CURRAGH RESOURCES INC.

SUBJECT: Dy Decline Drilling

SUBJECT: DY DECLINE DRILLING

*Dy Deposit
Underground
Decline*

The following is the initial
Drill proposal - for your
information only -

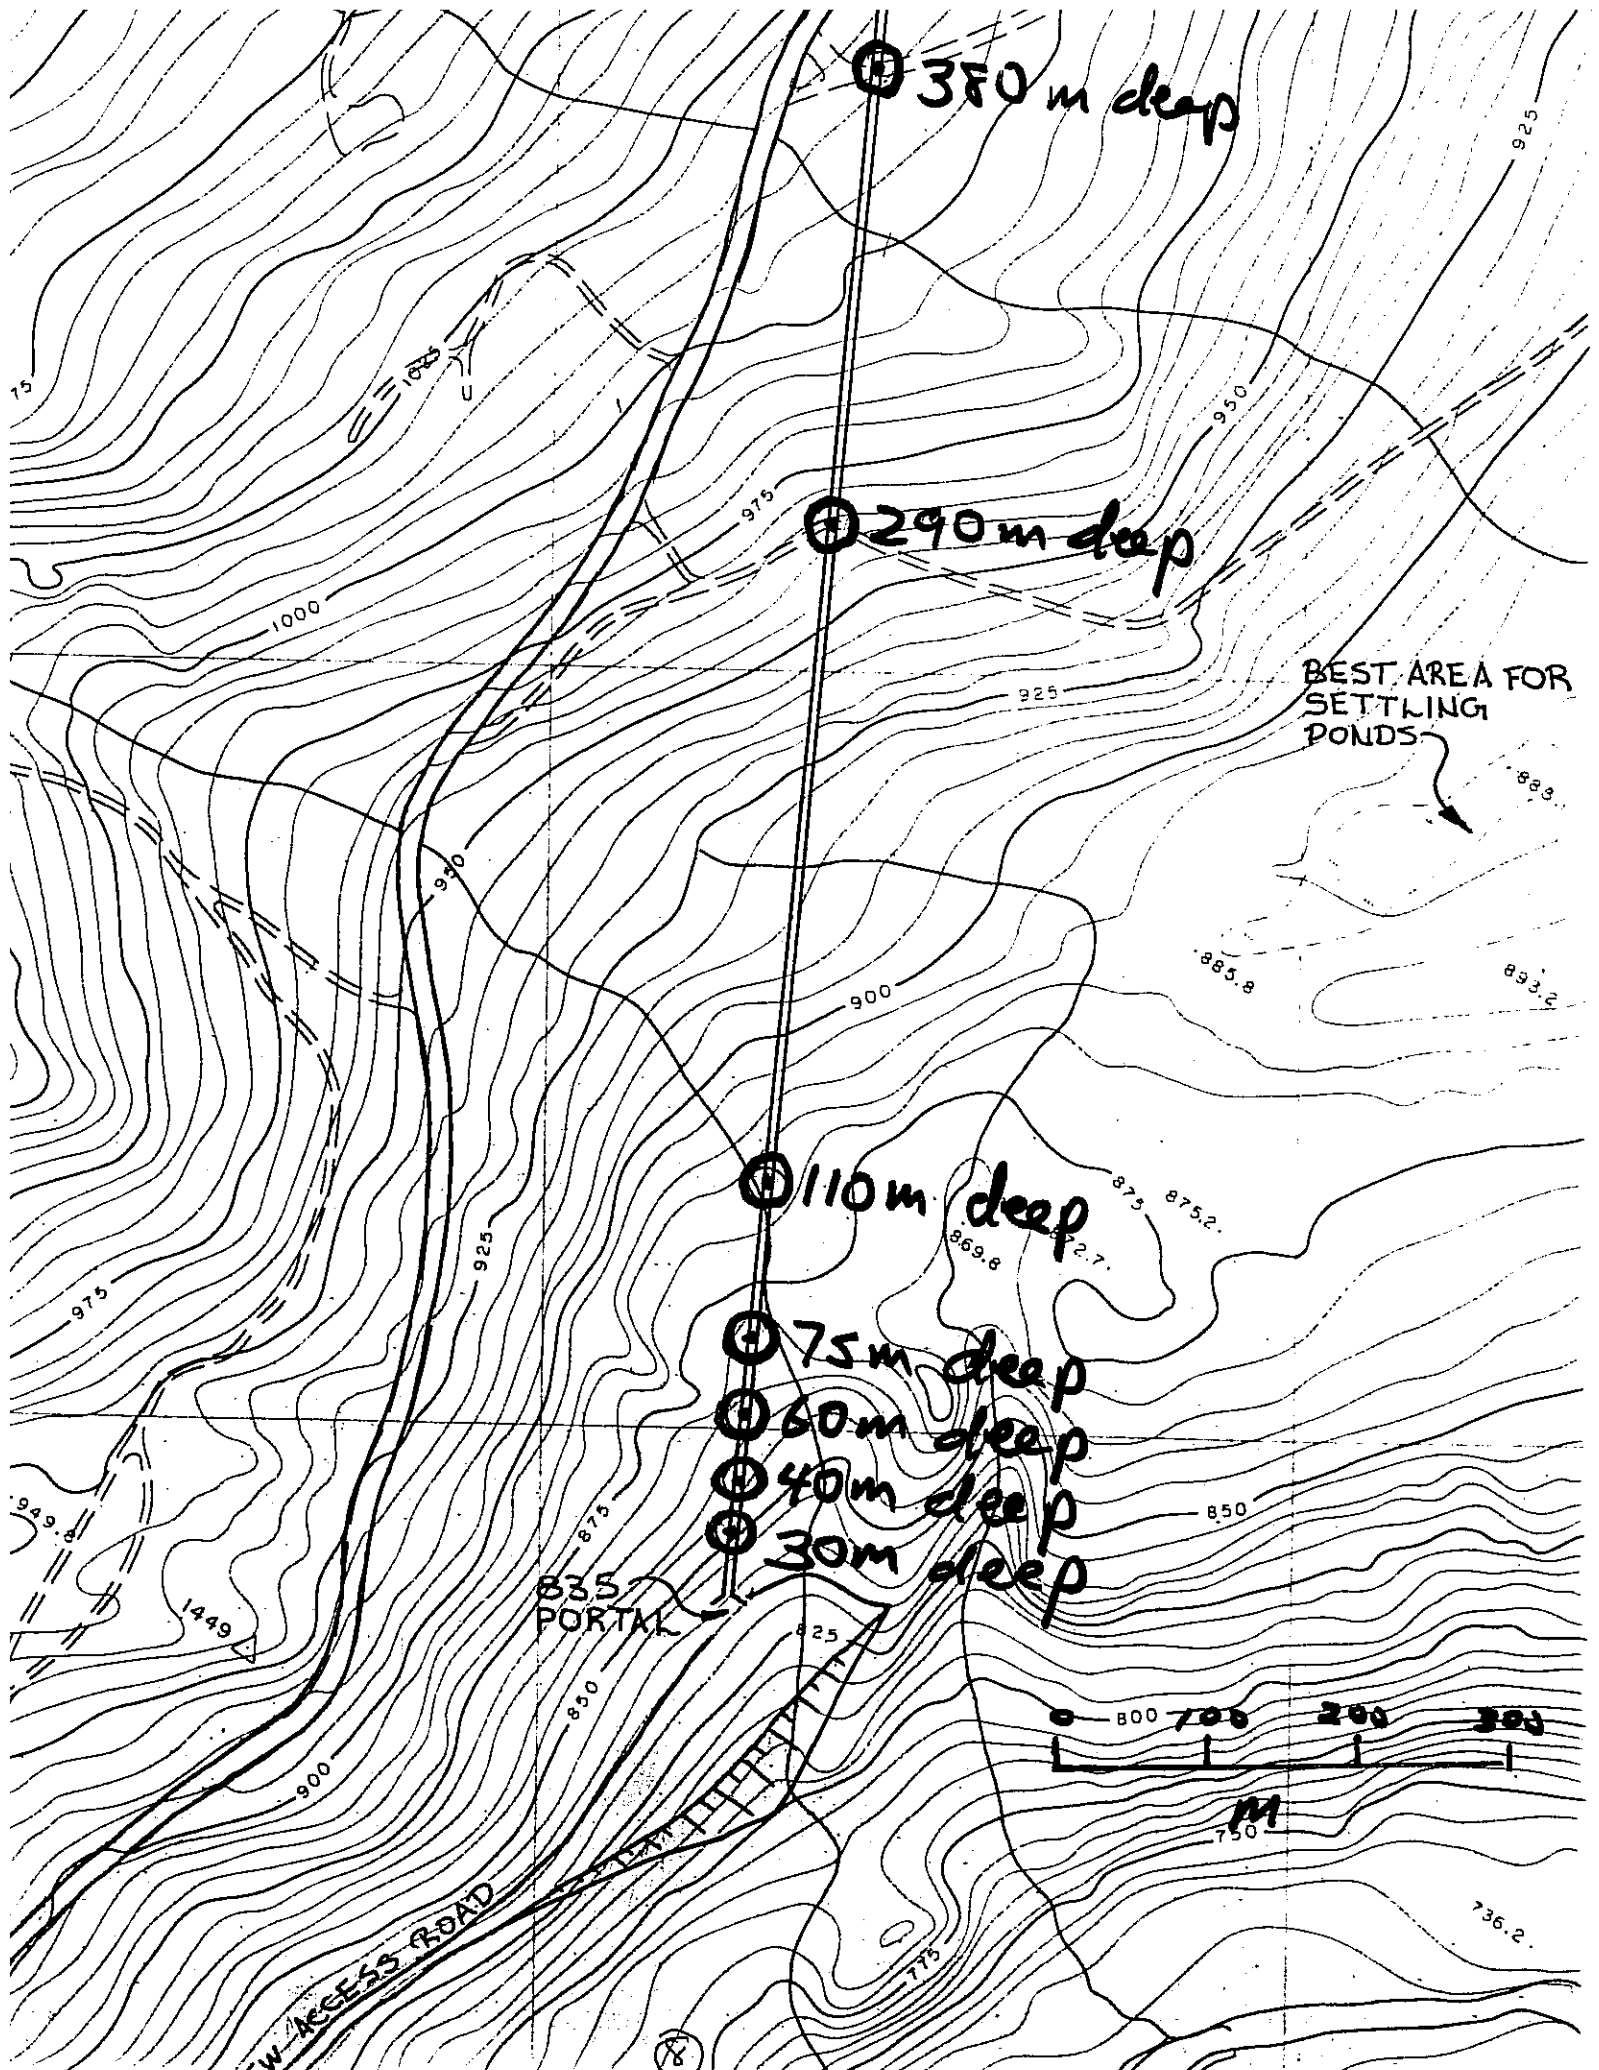
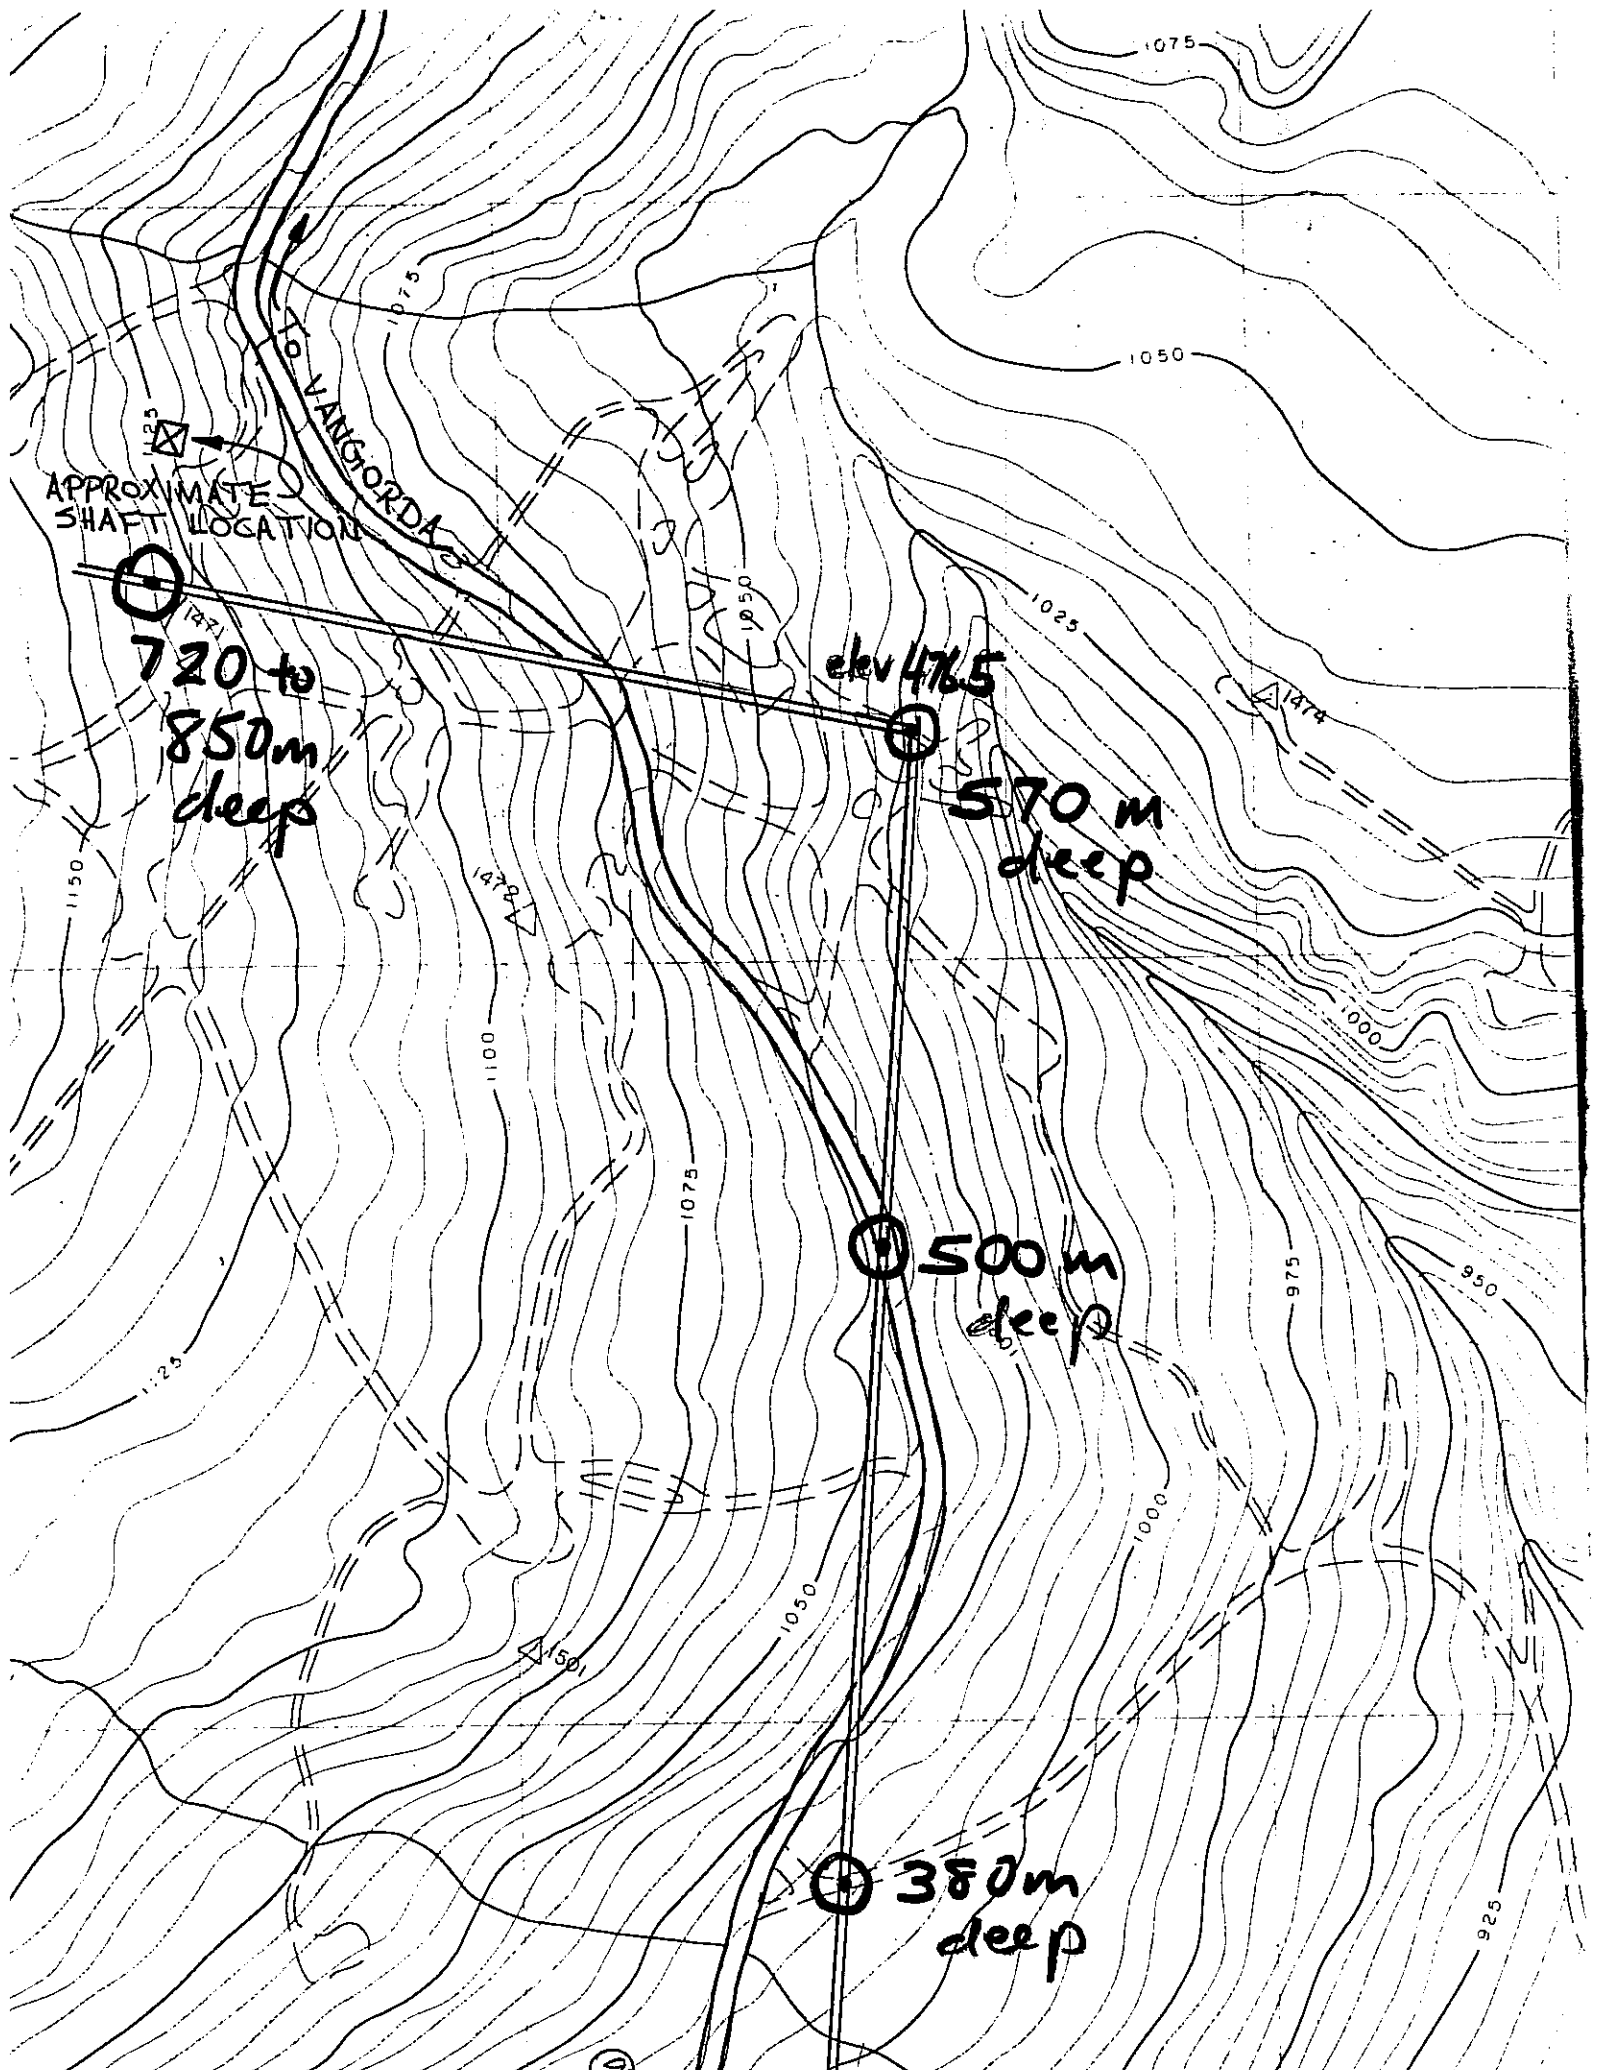
- o As a minimum, you must drill 5 holes at the portal. I have walked the site and believe we would be making a grave error in short changing ourselves on information at the most critical point of the project - the entry. This is only 15 meters more than the 'reduced' proposal (total drilling 315 meters).

- o 6th hole as per Gregg's proposal at 965 m elevation (topo) 290 m depth.
- o 7th hole as per Gregg's proposal at intersection - 570 m depth.
- o Hole 81X02 should provide sufficient information for ground between 6th and 7th hole.

- o Total drilling required 1,175 meters. Based on your numbers (assuming \$150/m or \$147.42/m / 3.28 = \$44.95/ft) the cost would be \$173,222.
- o Don't understand why rate is so high - last drilling done at CRI - Faro was about \$28/foot including assays? Are we getting a quote on directional control holes?

- o I would suggest we:
 - drill intersection hole first under control conditions to ensure we are away from the 'possible' fault or major structure that exists to the immediate east (as indicated by topo);

- drill portal entry holes (1, 2, 3, 4 and 5) second and in sequence.
- o Drill number 6 hole last.

NOTE: It should be considered by Gregg to drill #6 or #5 with directional control and cased so that we can pump to the proposed settling basin via one of these holes.

G. Jilson: I agree with this approach and as per our discussion
